## Product Change Notice (PCN)

PCN Number: **PCN-0451130R-01**

Product(s) Affected: **PJ-031CH**

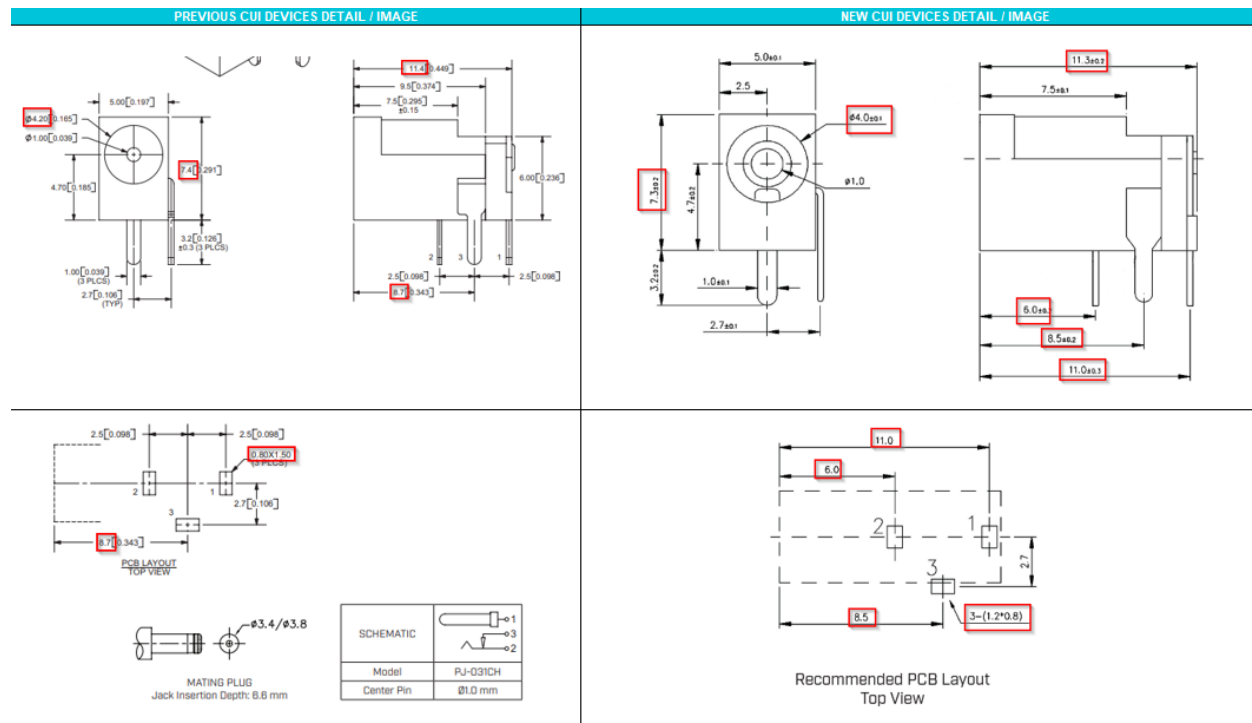
Description of Change: **Mechanical, electrical, and material changes as shown below:**

MATERIAL	PLATING
center pin	copper	nickel
terminal 1	brass	silver
terminal 2	copper alloy	silver
terminal 3	brass	silver
plastic	PBT

DESCRIPTION	MATERIAL	PLATING/COLOR
center pin	brass	silver
terminal 1	brass t=0.50	silver
terminal 2	MM alloy t=0.20	silver
terminal 3	brass t=0.50	silver
housing	PA10T (UL94V-0)	black
